Balanced Technology Extended (BTX) Interface Specification

Errata A

Errata A, February 2004

The errata in this document are corrections and clarifications for the *Balanced Technology Extended (BTX) Interface Specification, Version 1.0* released September 2003.

Figure 2. BTX Form Factor Board and Mounting Hole Dimensions

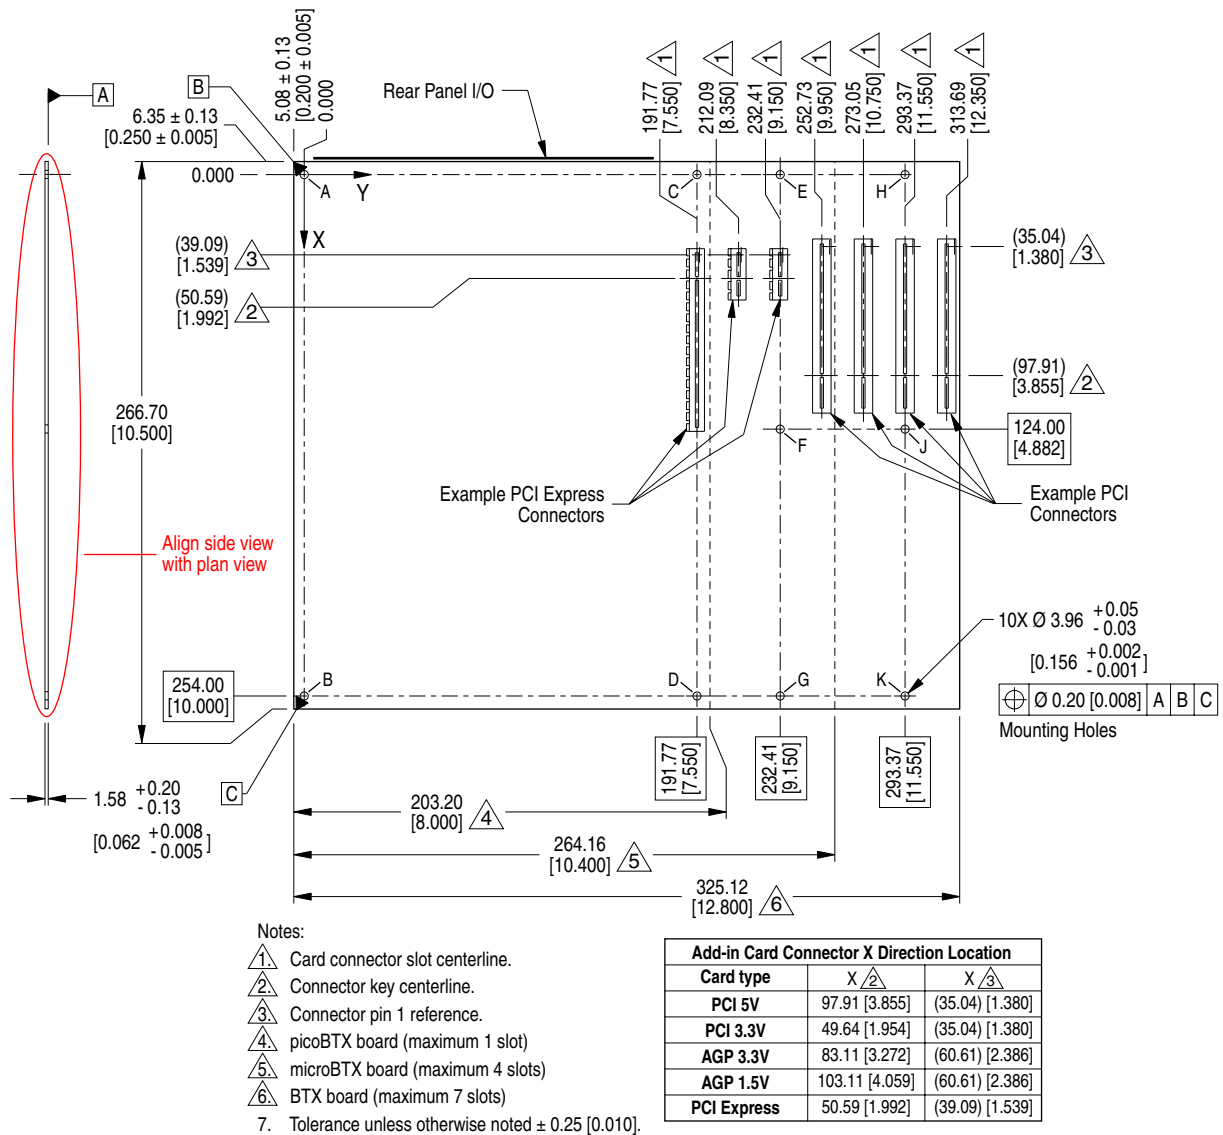
To correct an error in the original figure, align the side view with the plan view as indicated in Figure 2, page 12.

Figure 5. Motherboard Secondary Side Volumetric Zones

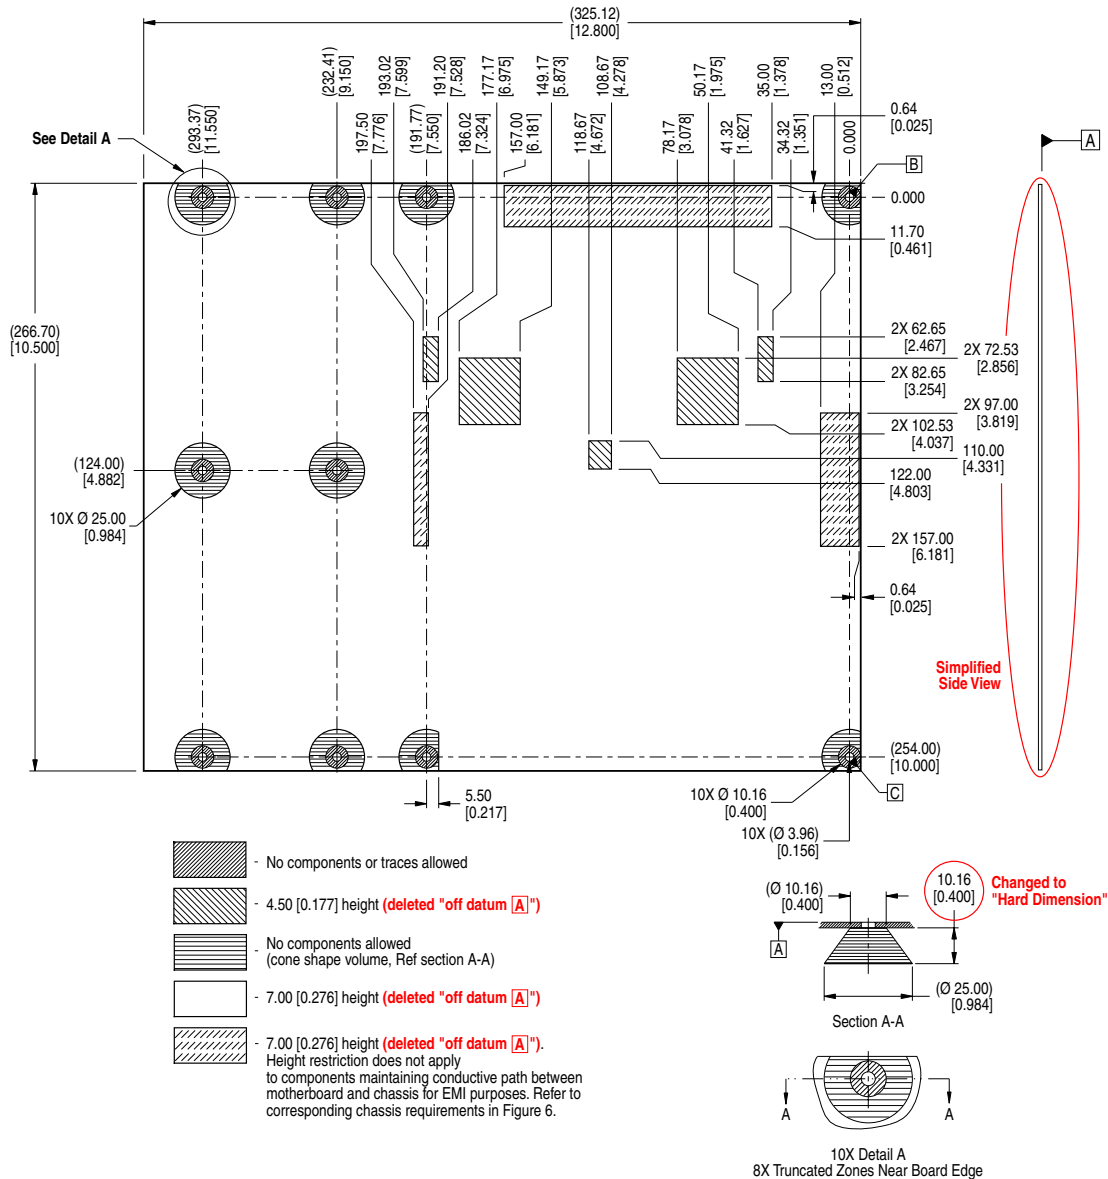
To correct errors in the original Figure 5, page 16:

- To resolve an inconsistency between Figure 5 and the specification text, delete the references to Datum A. As stated in the text, the volumetrics in this figure should be referenced from the bottom side of the motherboard.
- To clarify the figure, simplify the side view as shown.
- 10.16 should be a “hard dimension” rather than reference.

Figure 6. Chassis Volumetric Zones

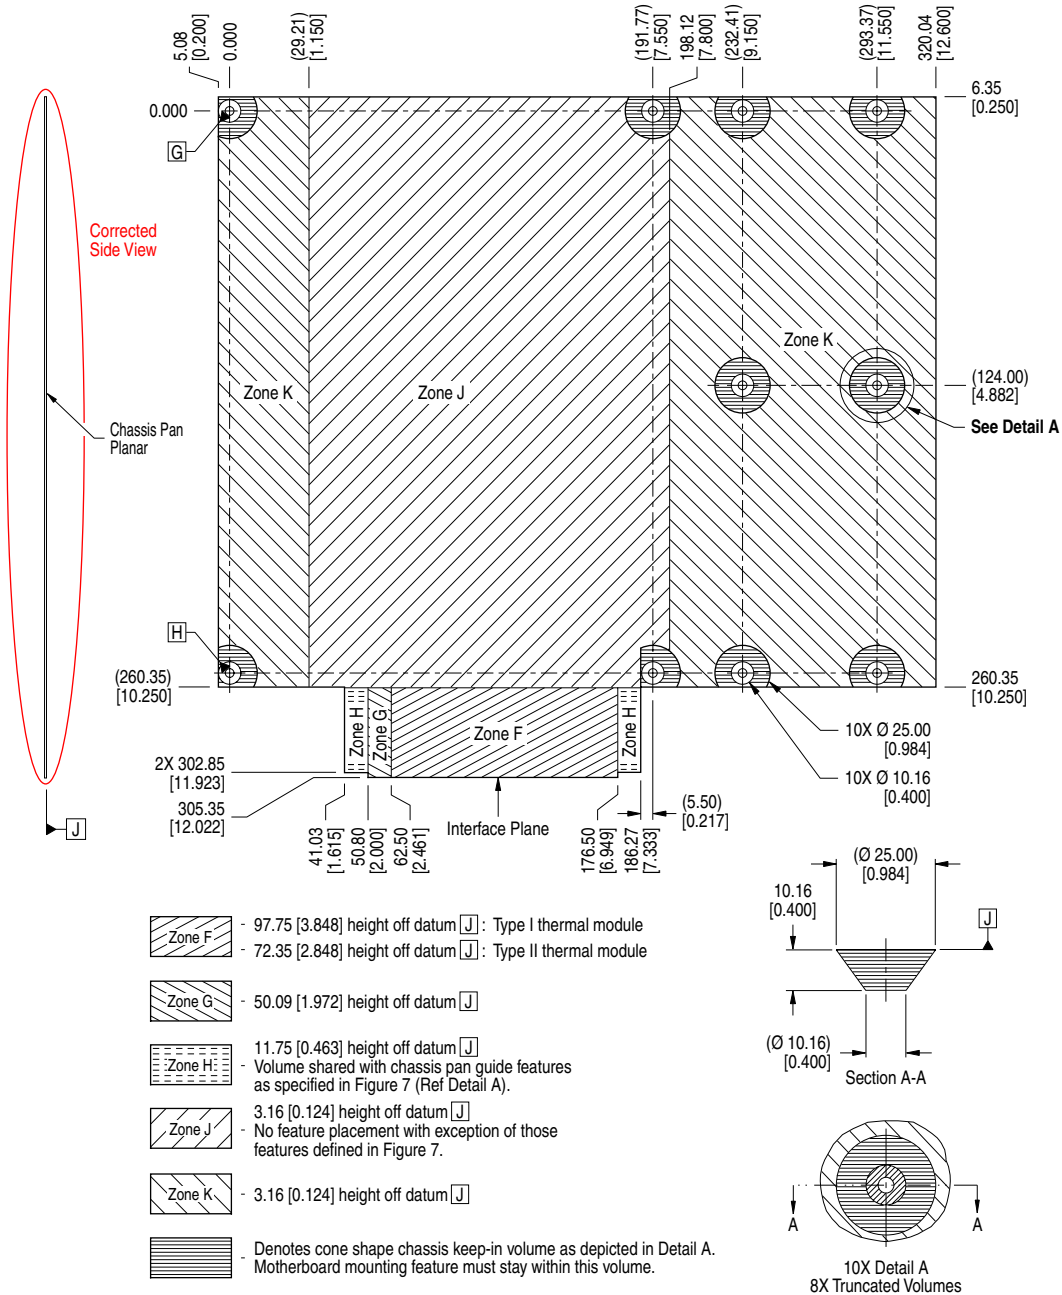
To correct an error in the original figure, correct the side view as indicated in Figure 6, page 18.

Figure 7. Chassis Interface to SRM Requirements

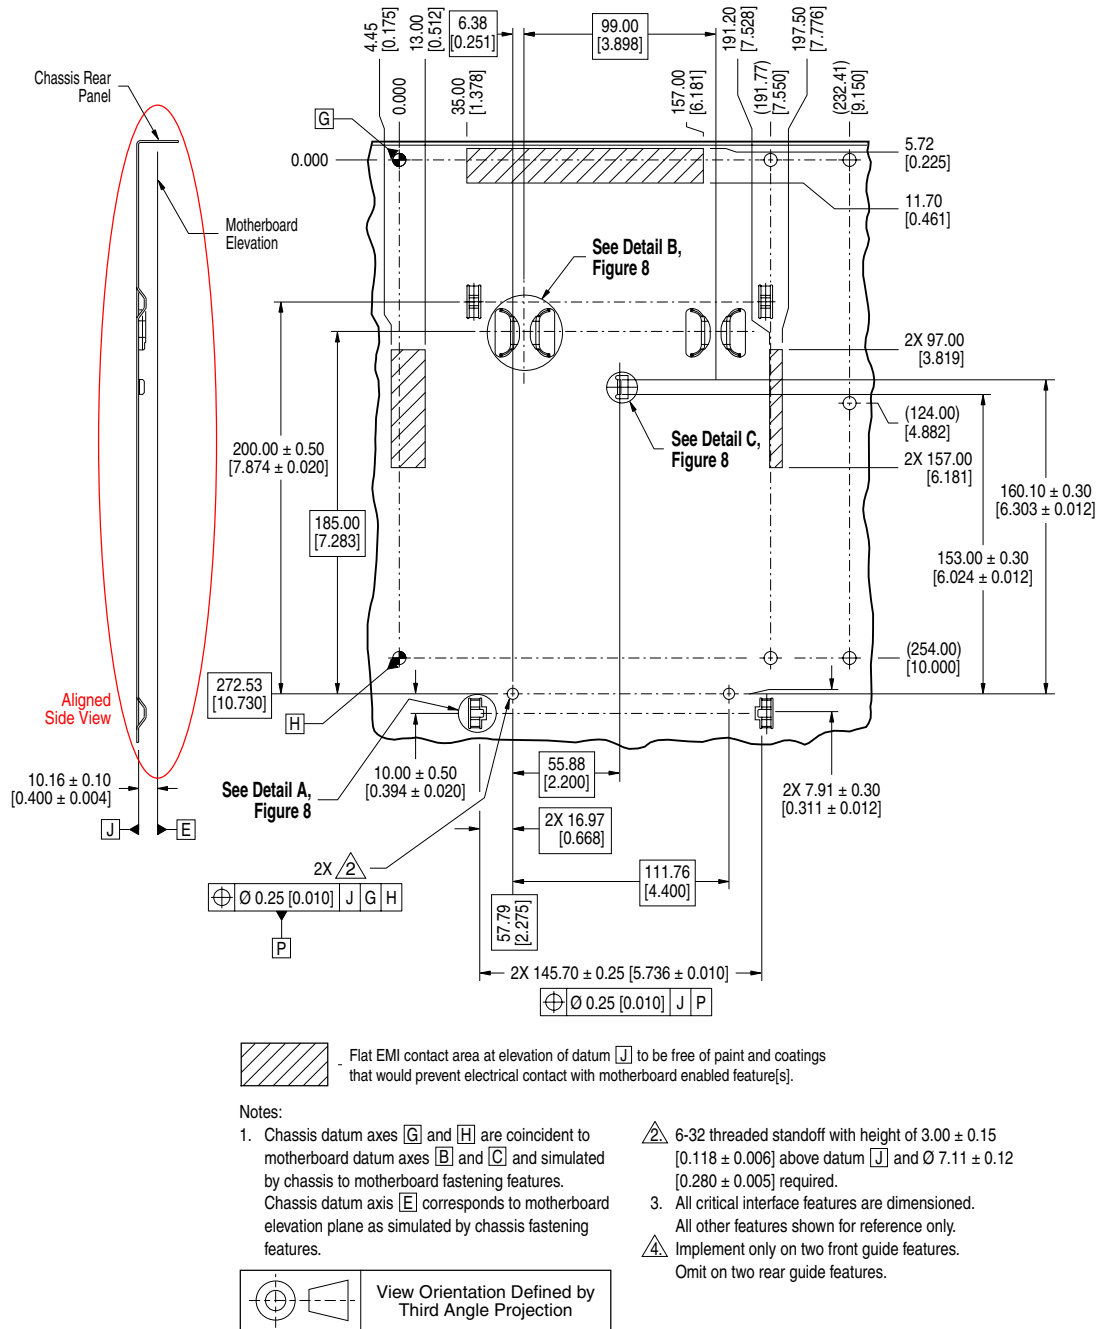
To correct an error in the original figure, align the side view as indicated in Figure 7, page 20.

Figure 8. Chassis Interface to SRM Requirement Details

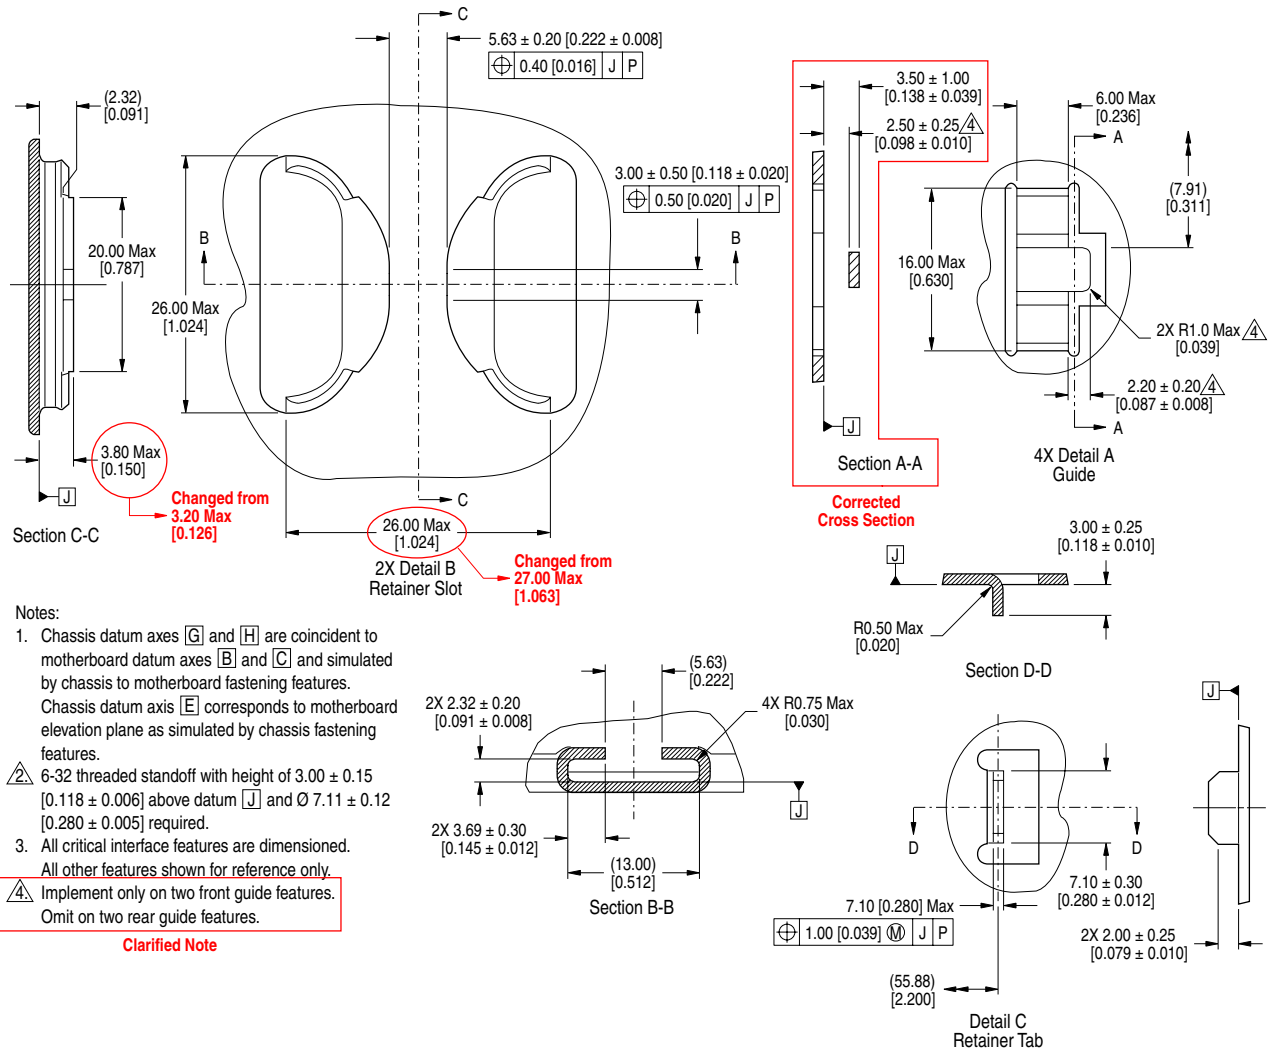
To correct errors in the original Figure 8, page 21:

- Change the dimensions as indicated.
- Clarify Note 4 as shown.
- Correct Section A-A. In the original figure, the cut was made in the wrong orientation. (No dimensions were changed in Section A-A.)

Figure 10. Chassis Requirements for Thermal Module Interface Definition

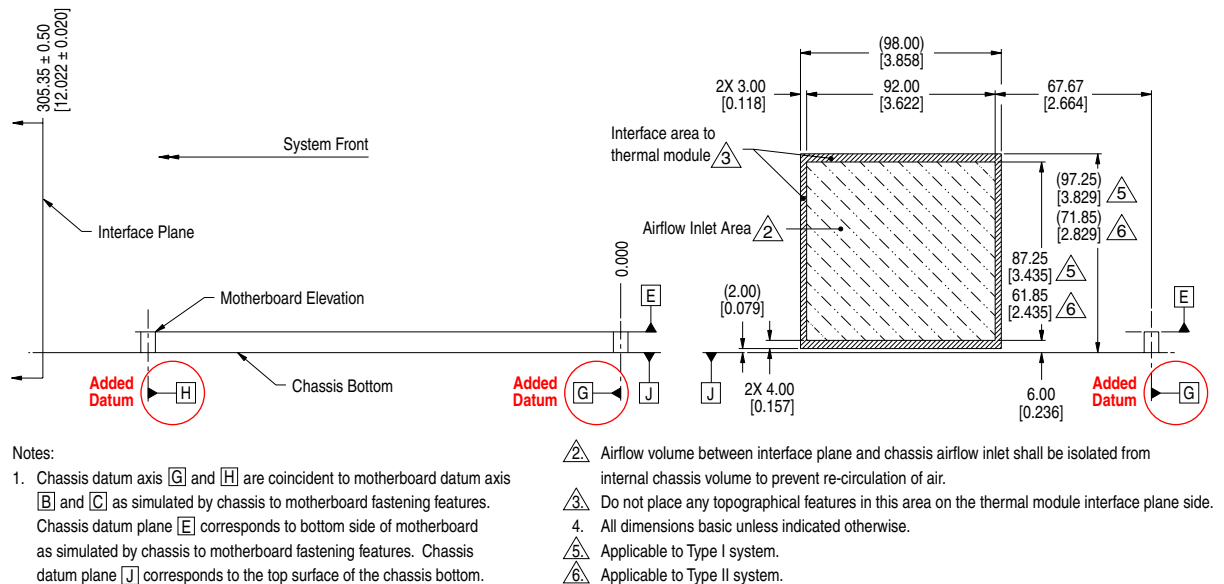
To correct errors in the original figure, add Datum Axes G and H to the side view and Datum Axis G to the plan view as indicated, in red, in Figure 10, page 23.
